SUBJECT: GENERAL PLAN AMENDMENT NO. 08-001, ZONING MAP AMENDMENT NO. 08-001, LOCAL COASTAL PROGRAM AMENDMENT NO. 08-001, CONDITIONAL USE PERMIT NO. 08-014, COASTAL DEVELOPMENT PERMIT NO. 08-008, DESIGN REVIEW NO. 08-047, VARIANCE NO. 08-009, ENVIRONMENTAL ASSESSMENT NO. 08-004, TENTATIVE TRACT MAP NO. 17233 (HARMONY COVE RESIDENTIAL CONDO AND MARINA DEVELOPMENT)—3901 WARNER AVENUE PROJECT IMPLEMENTATION CODE REQUIREMENTS

**CITY OF HUNTINGTON BEACH
DEPARTMENT OF BUILDING & SAFETY
PROJECT IMPLEMENTATION CODE REQUIREMENTS**

PROJECT NAME: HARMONY COVE RESIDENTIAL DEVELOPMENT

The City of Huntington Beach requested that Moffatt & Nichol (M&N) review the proposed marina slip layout of Harmony Cove in Huntington Harbour and comment on potential areas of concern, including navigational impacts, limitations on future expansion, and operational considerations.

FIGURE 1 – CHANNEL WIDTH

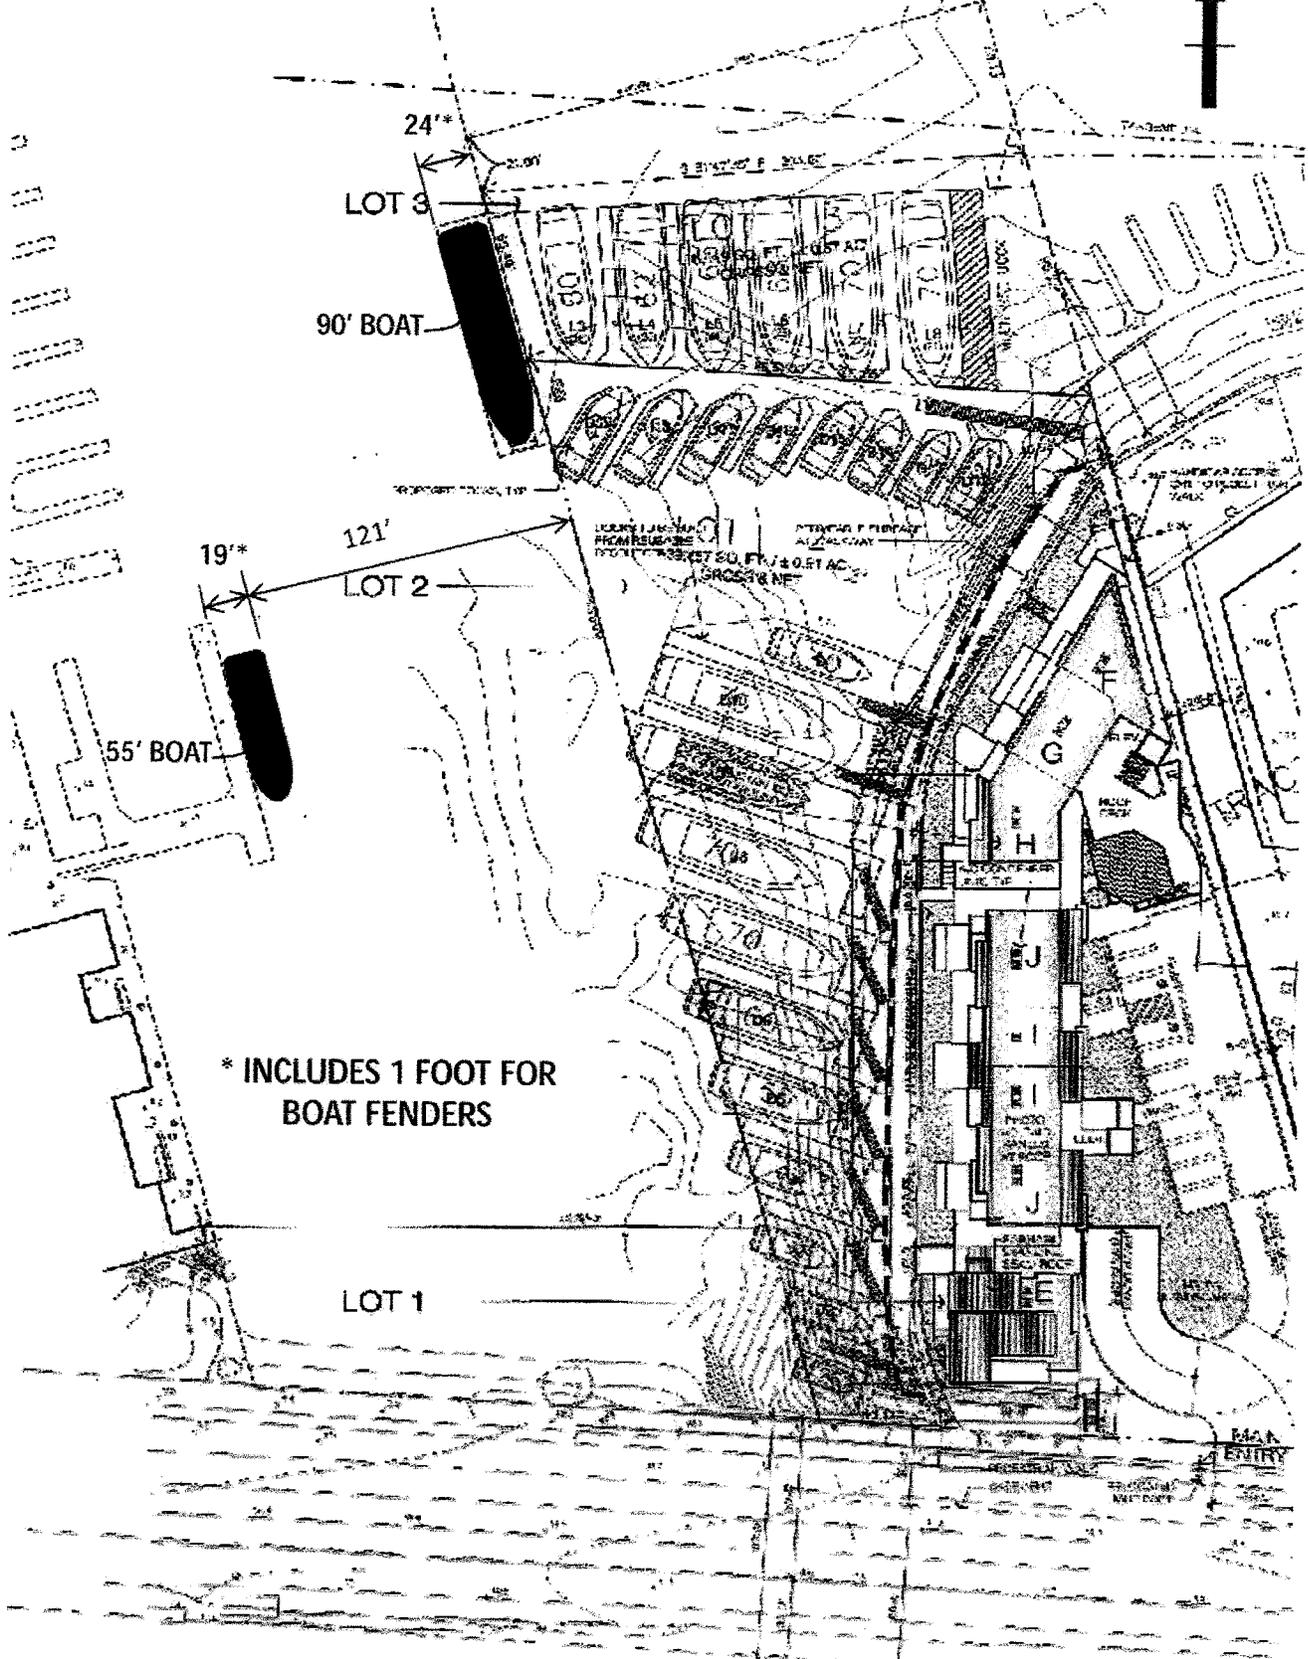
The exhibits VM-1 thru VM-3 from the URS letter and the Site Plan / Roof Plan from January 2009 show channel width dimensions from 125 feet to 140 feet between the existing public dock and the proposed Harmony Cove boats and docks. The DBW guidelines recommend a minimum interior channel width of 75 feet, so this minimum is met. Applying the five beam width criterion for a design vessel of 55 feet in length with an 18 foot beam, the minimum channel width would be 90 feet. This criterion is also met as illustrated in the attached Figure 1.

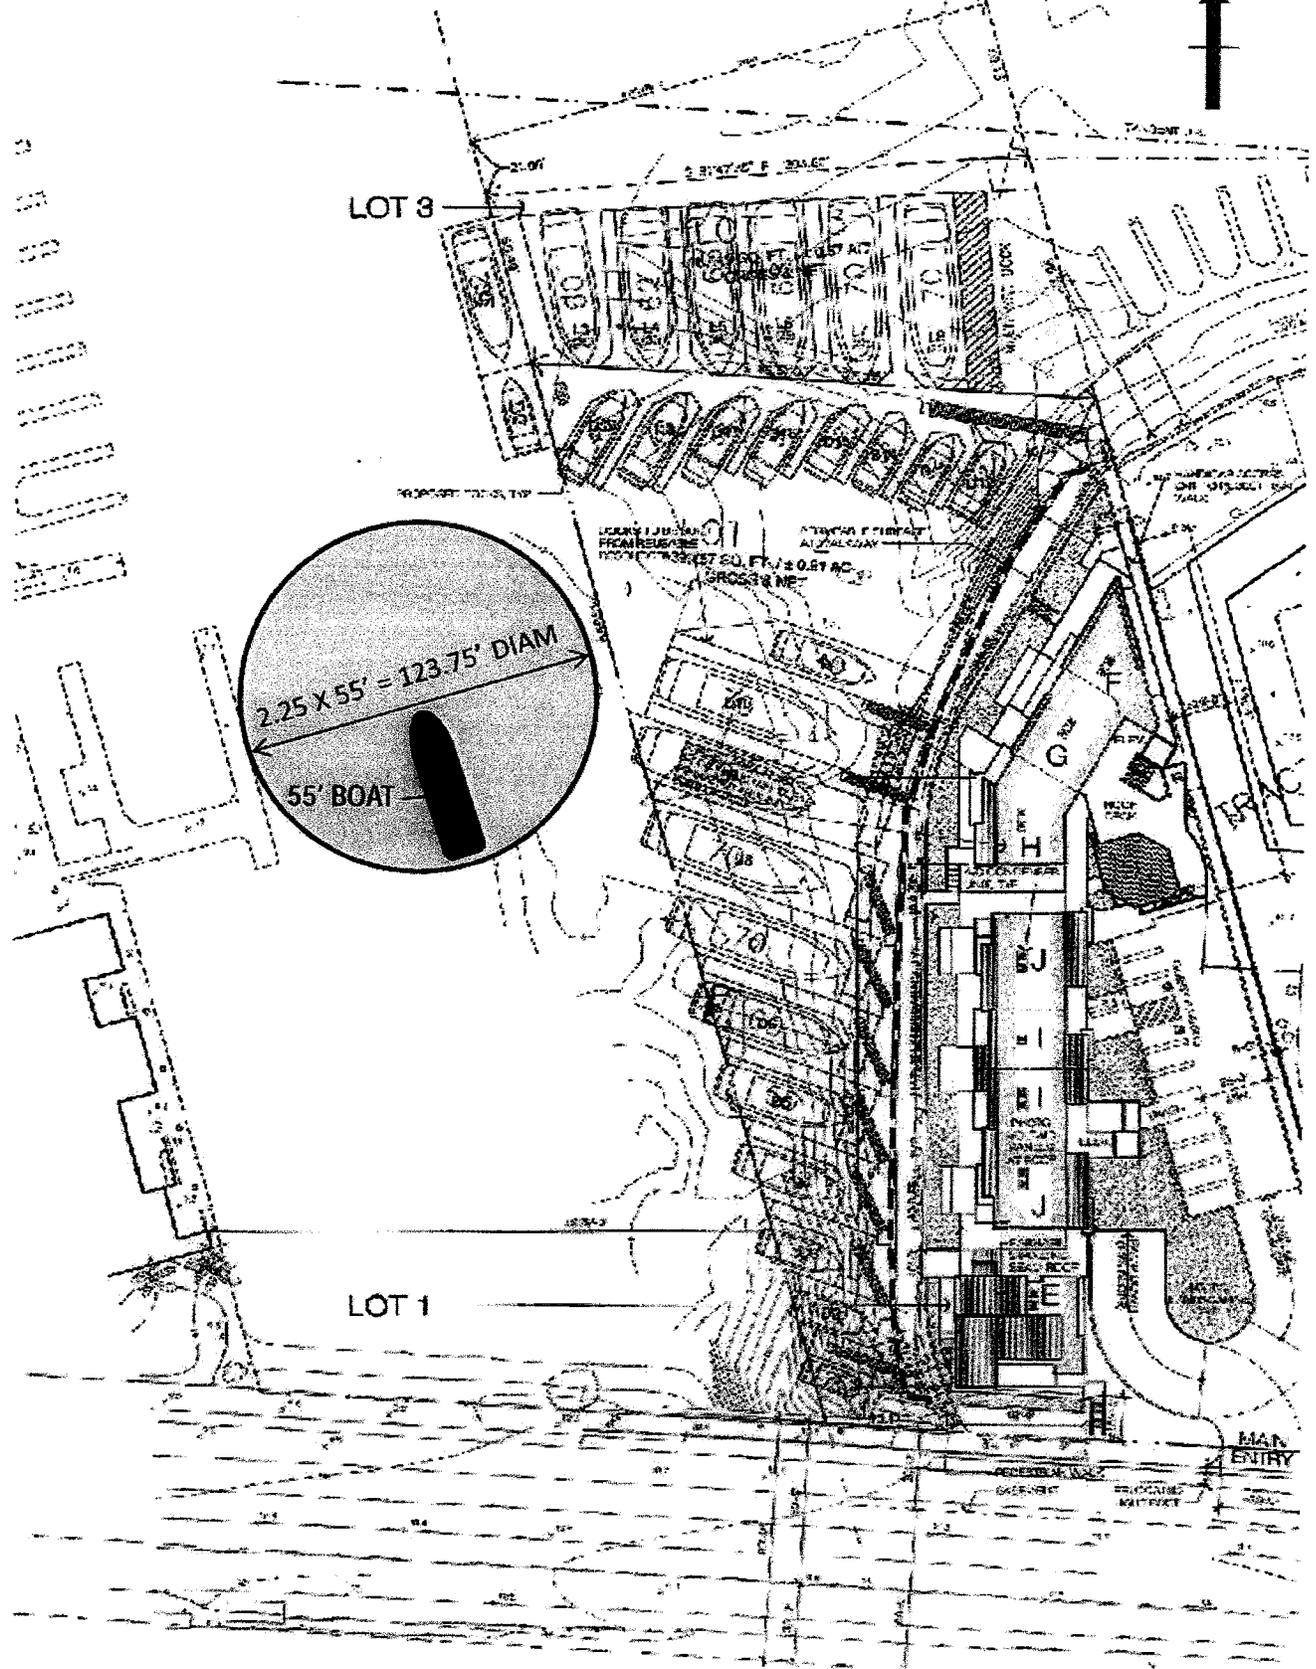
Vessel backing distances shown in the latest plan for the marina appear to be adequate and meet the DBW guidelines. As illustrated in Figure 2, the 70 foot slips in the new development require 122.5 feet backing distance. Even with a 55 foot vessel berthed at the adjacent public dock, the 121 feet of available fairway width is sufficient. It should be noted that the size of vessel currently shown in proposed boat slip D11 is 40 feet long and would need to remain limited to that size to avoid future backing distance issues with slips D12 thru D16.

CASE 3 – TURNING BASIN

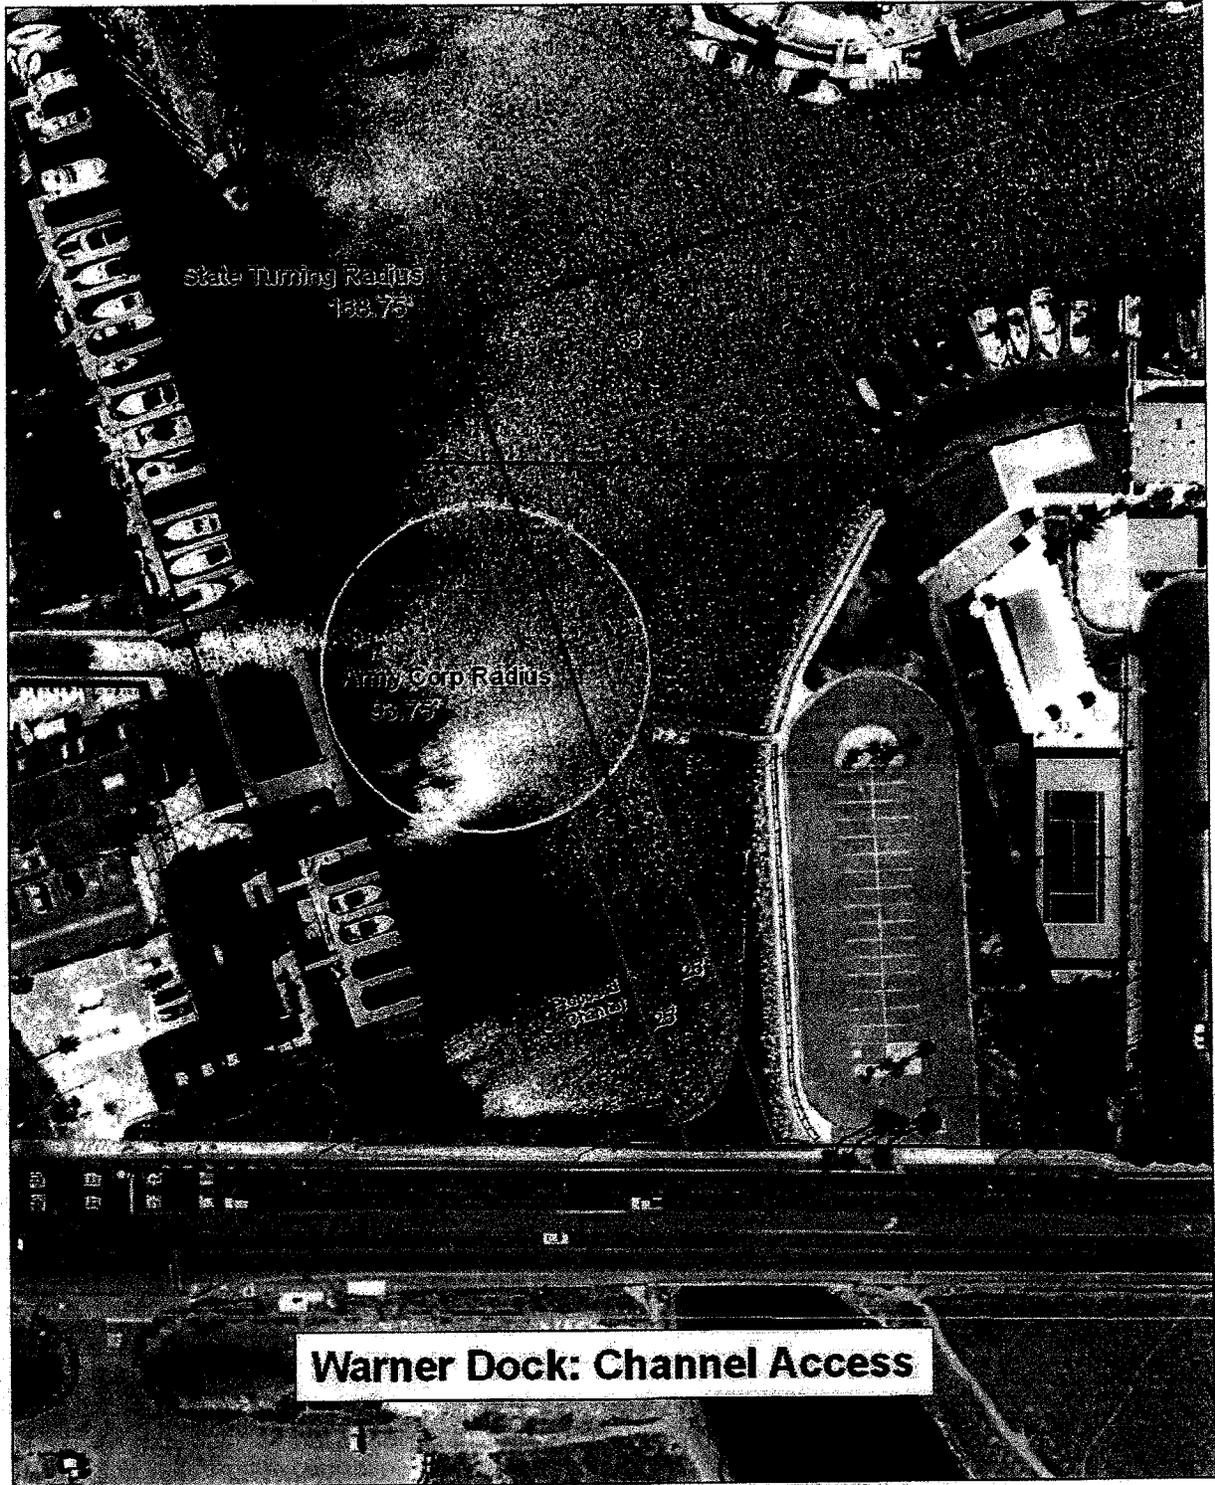
As illustrated in Figure 3, a minimum turning basin diameter of 123.75 is recommended to account for a 55-foot vessel accessing the public dock and pumpout. Larger vessels such as either the 75 foot vessel that has been indicated to berth at the public dock, or the potential 90 foot vessel shown as a side-tie in the proposed marina development, must utilize the wider portion of the channel north of the proposed project.
